**PLAN COMMISSION
MEETING NOTICE AND AGENDA
Thursday, July 18, 2024
6:00 PM**

REPORT TO THE PLAN COMMISSION

Project Name: Comprehensive Master Plan Amendment, Rezoning, Certified Survey Map, and Site & Building Plan Review

We appreciate the opportunity to present a revised site plan to the City after the previous Plan Commission meeting on 6/20/24. In addition to the response letter provided to the City on 7/8/24 addressing comments received at that time, please accept the following narrative and voluntarily revised site plan for consideration of Uzelac’s new facility.

Exterior Photometric Lighting Plan

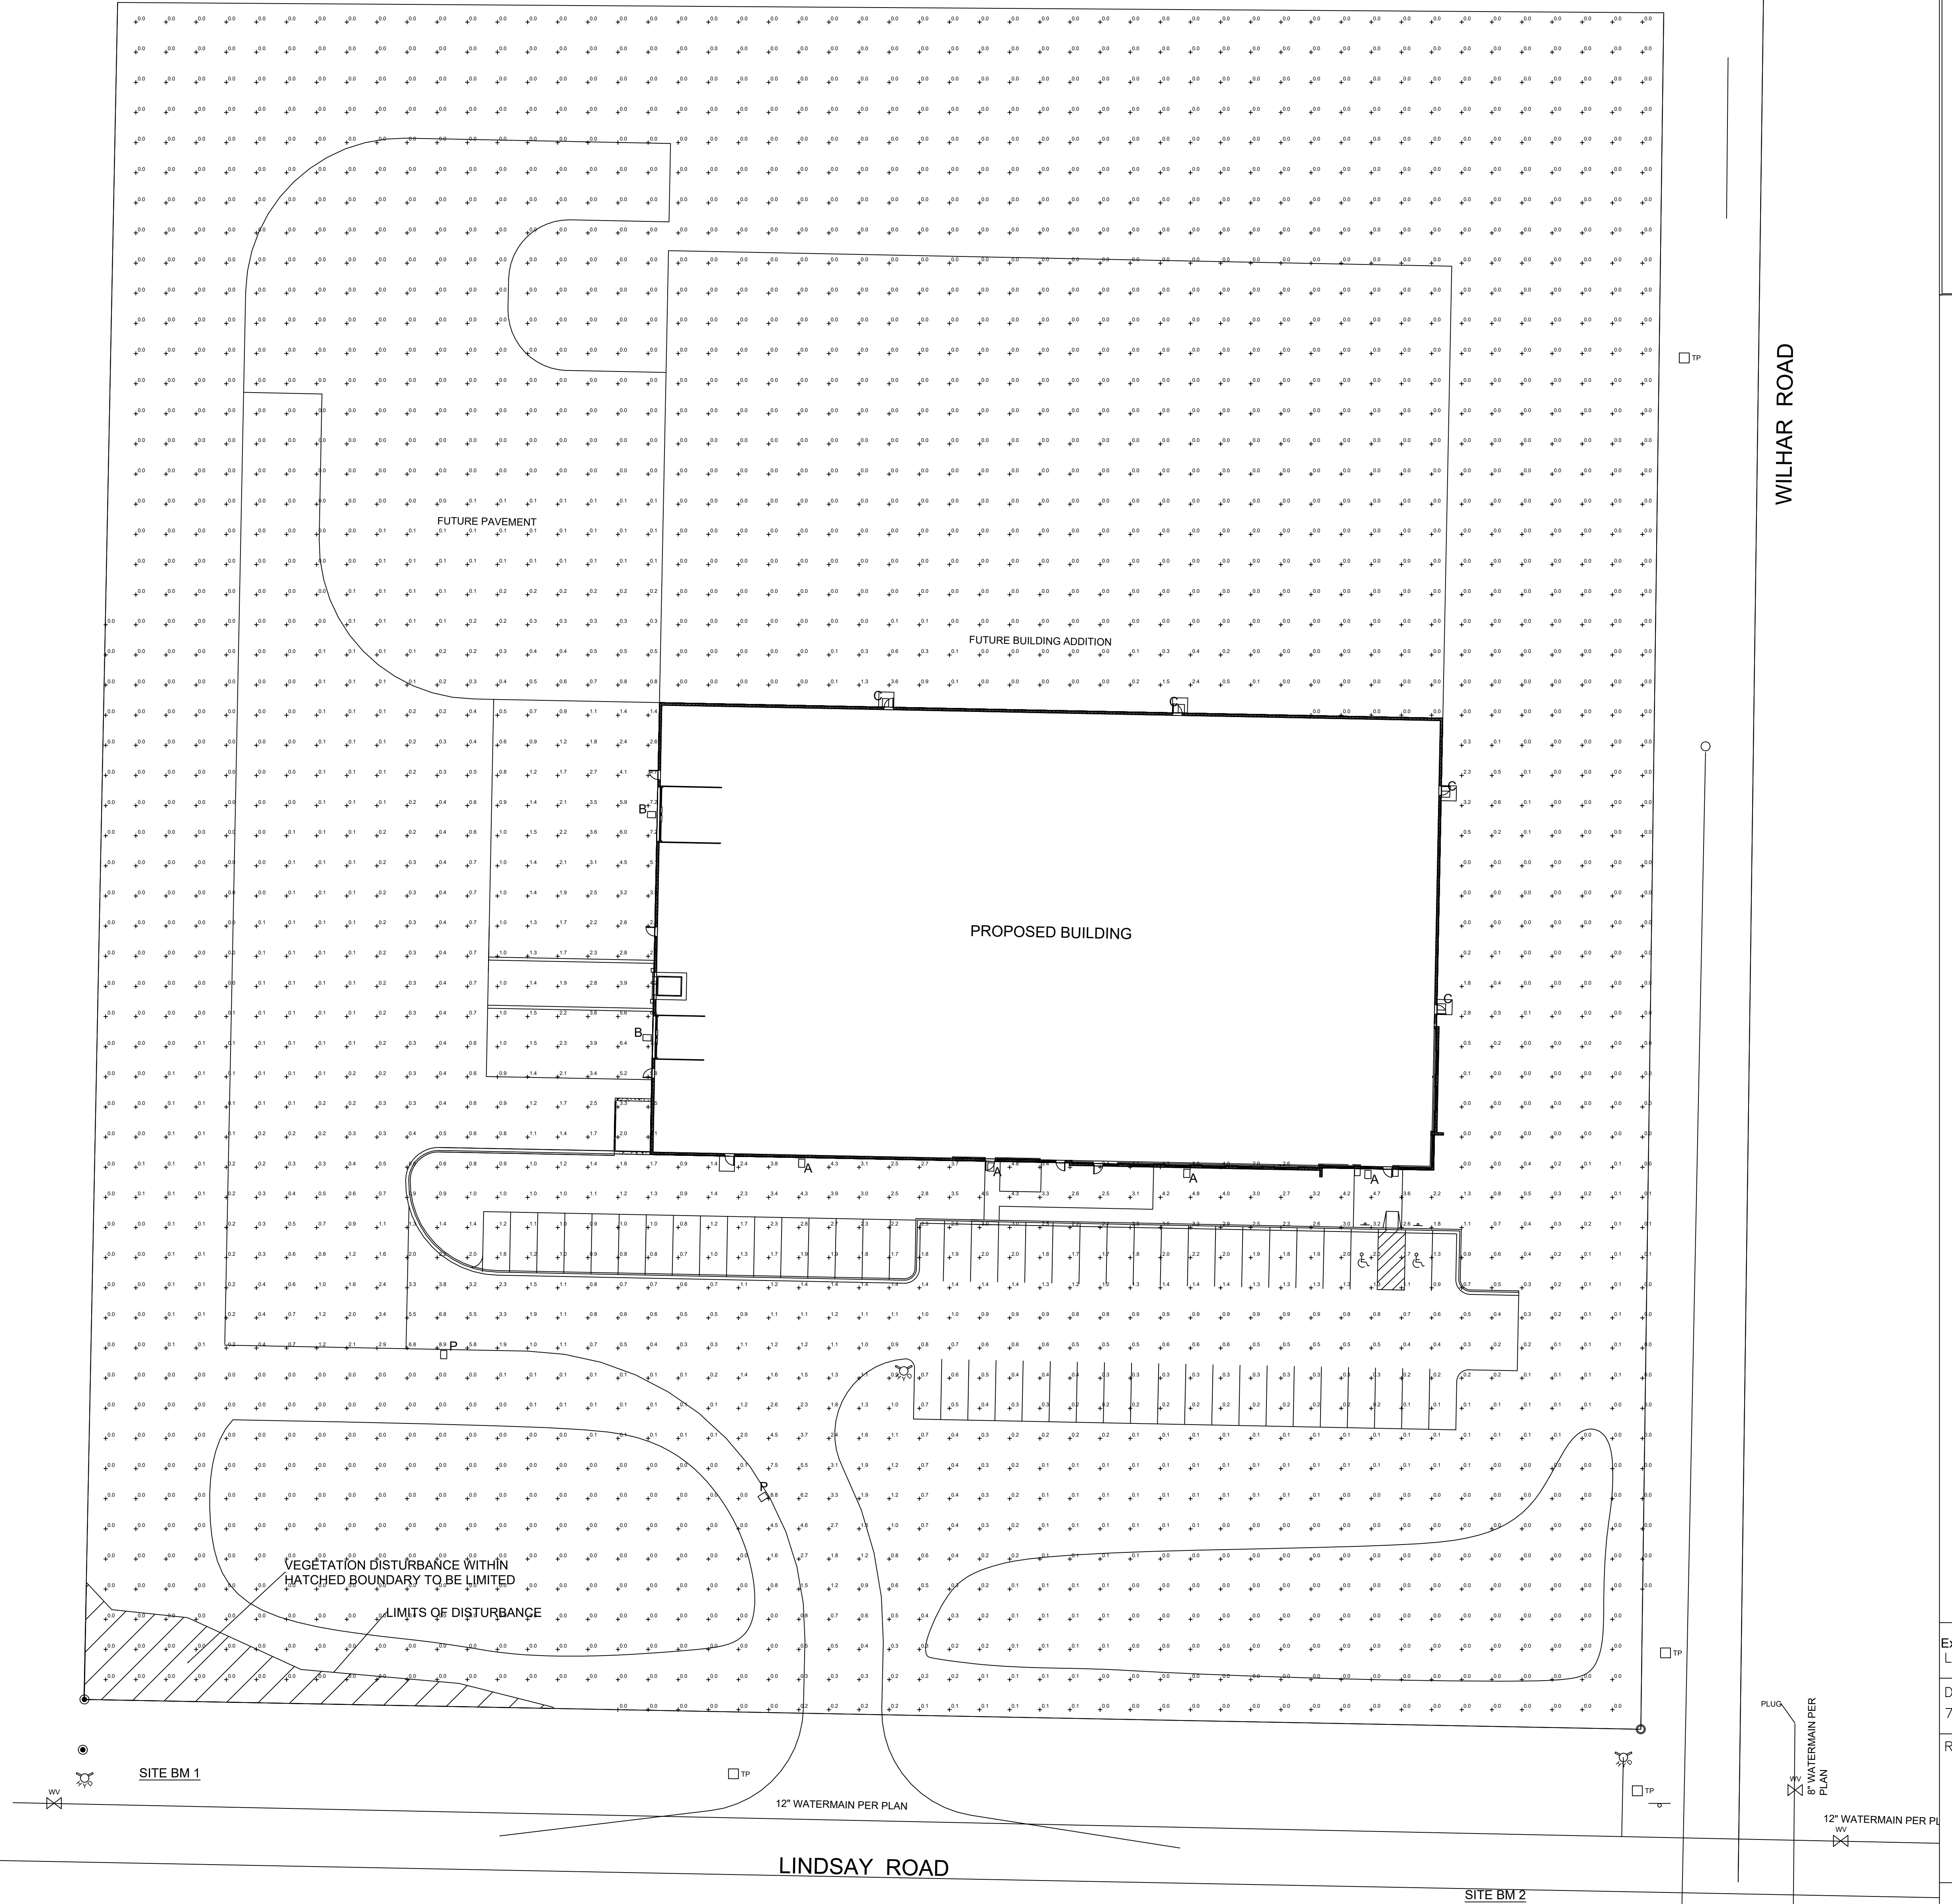
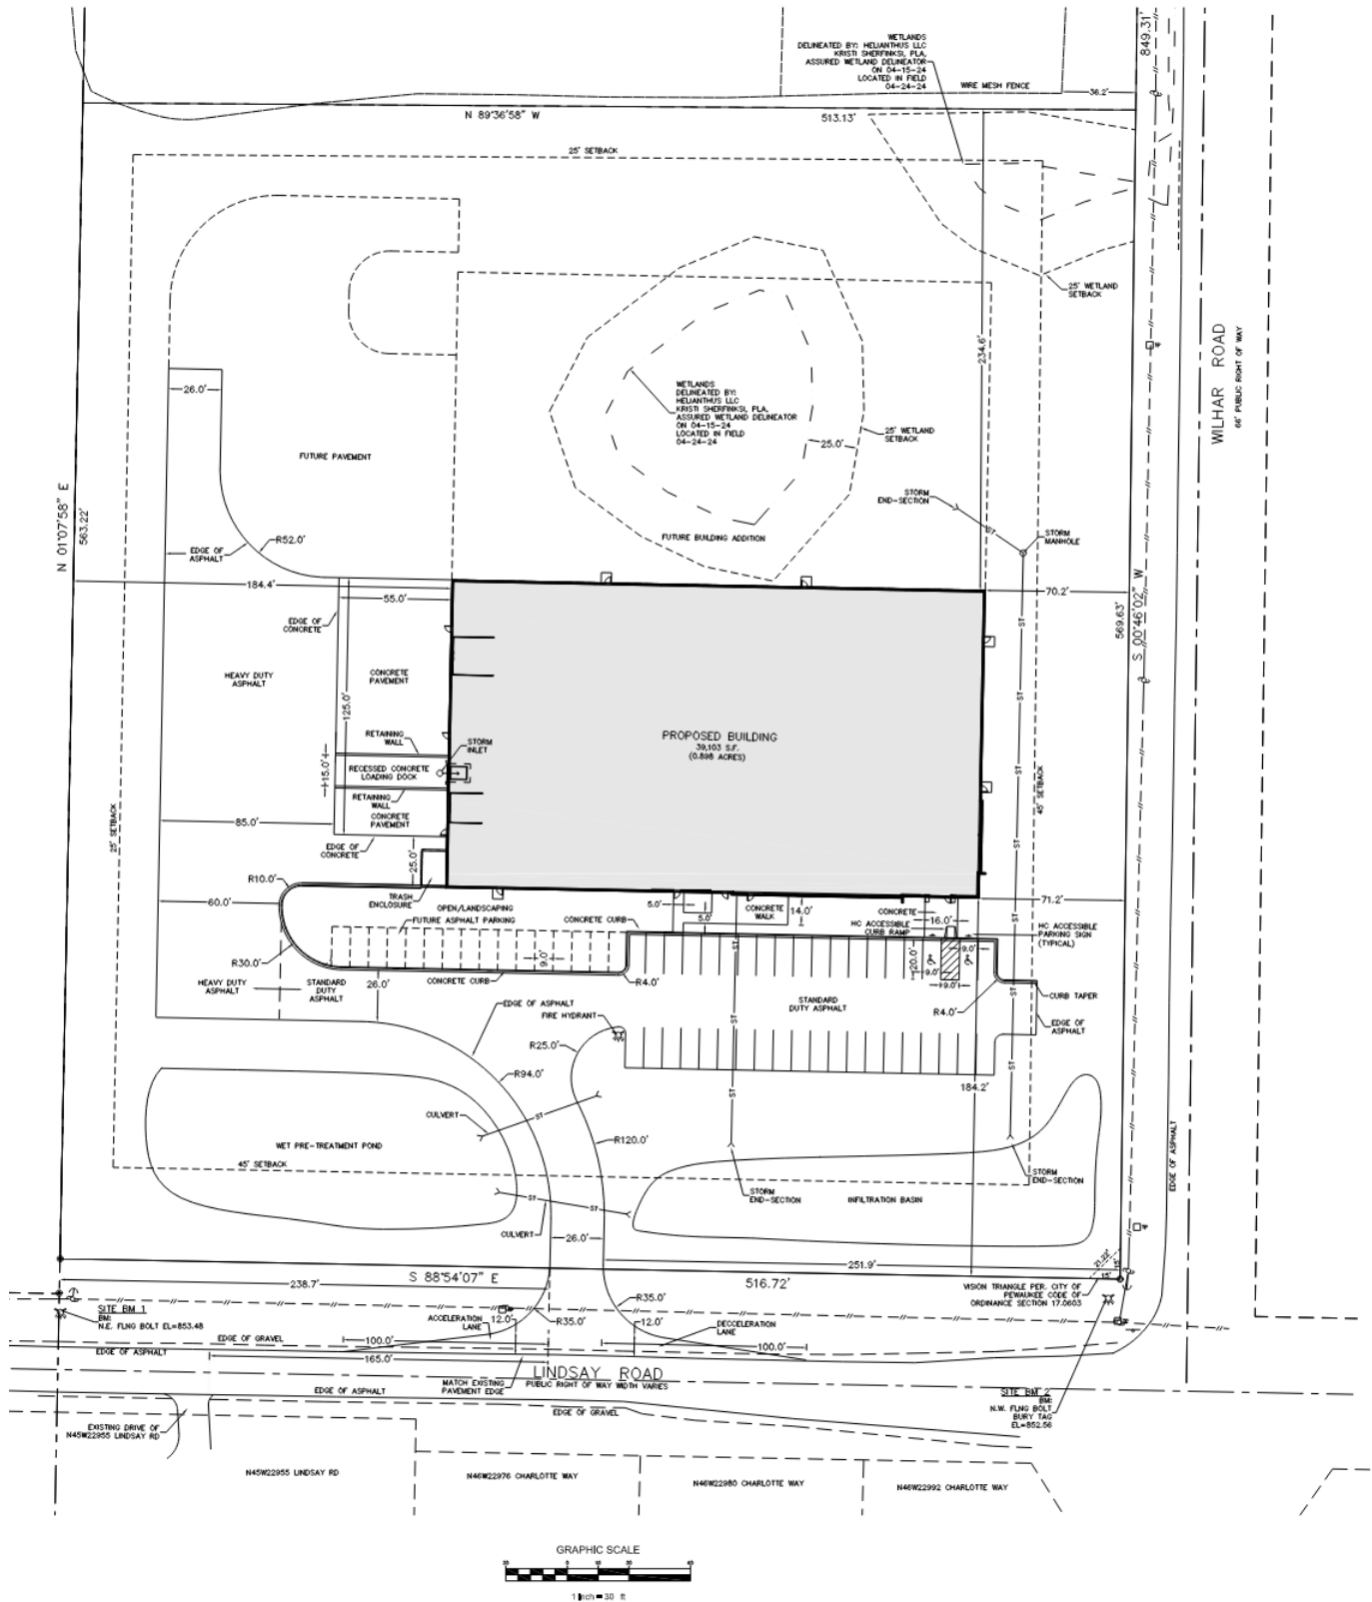
The Lighting Plan consists of ten building lights and one parking lot light. The parking lot light has a peak height of 19-feet and is located on the west side of the Lindsay Road entrance. Two types of building lights will be mounted at a height of 24-feet and the other type is mounted at 10-feet.

Lighting: The revised photometric plan, E-1.0, shows proposed levels of lighting at the property line to be 0.0 footcandles, unless at the ingress/access where it does not exceed 0.2fc for pedestrian safety. Additionally, in the southwest corner from the property line to the north, there is approximately 117 feet of area proposed for stormwater treatment and landscaping that will not be lit. This distance increases to approximately 153 feet from Lindsay Road, when including the right-of-way area to the property line.

Image 2: Voluntary revisions to driveway placement and landscape features

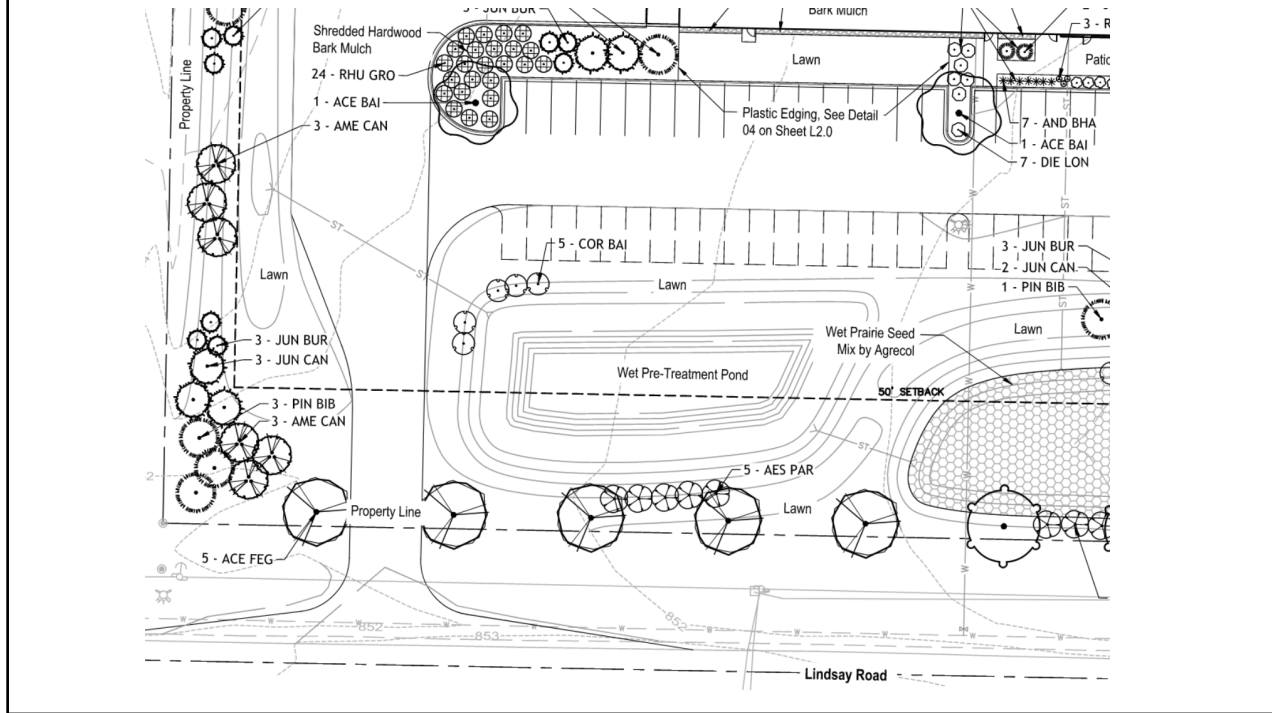
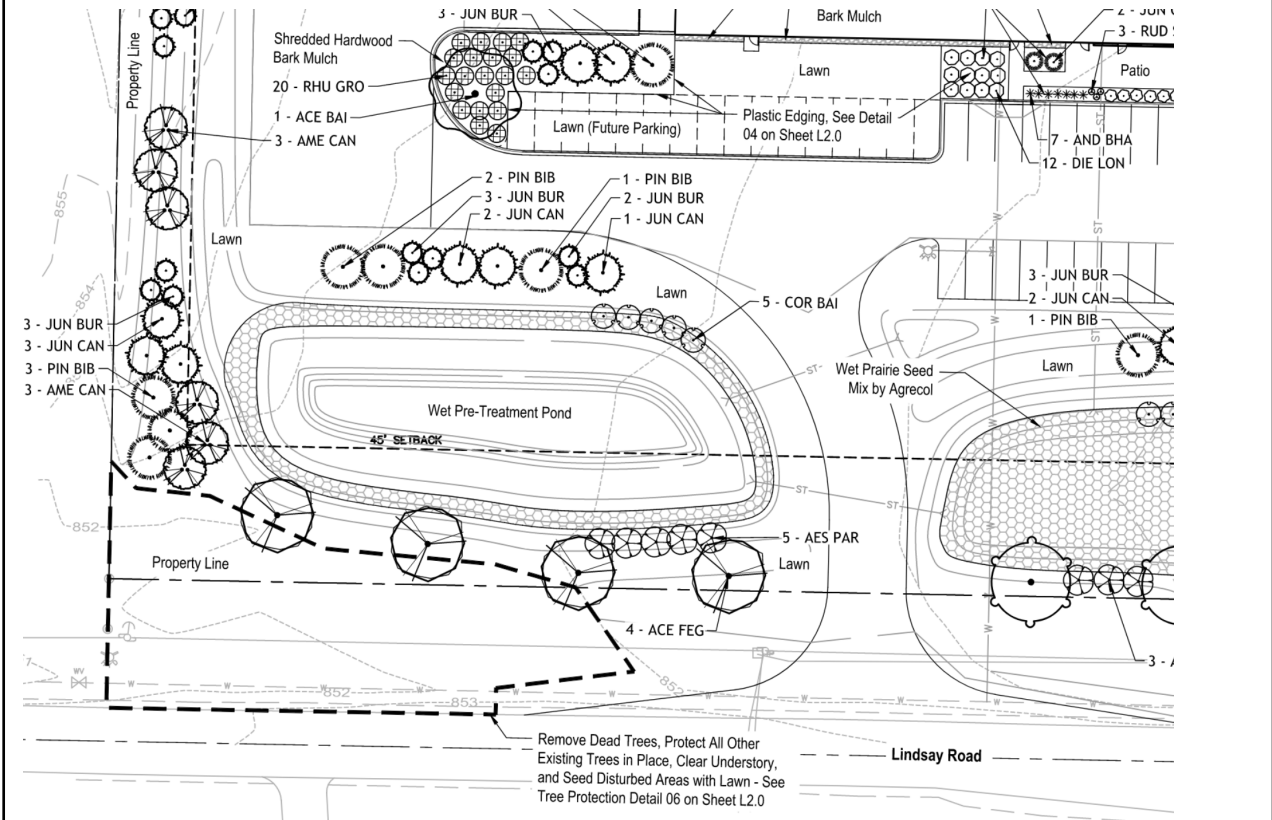
meaningful discussion at Plan Commission, the site plan was voluntarily revised to accommodate the well-being of the surrounding community by condensing access to one driveway off Lindsay Road and relocating the proposed ingress/egress driveway to the east 165 feet. This proposed revision avoids any and all further impact to Wilhar Road which was rated a 2 out of 10 level of service at the time of the public hearing. Additionally, relocating the driveway safely avoids conflict with private drives and the subdivision entrance.
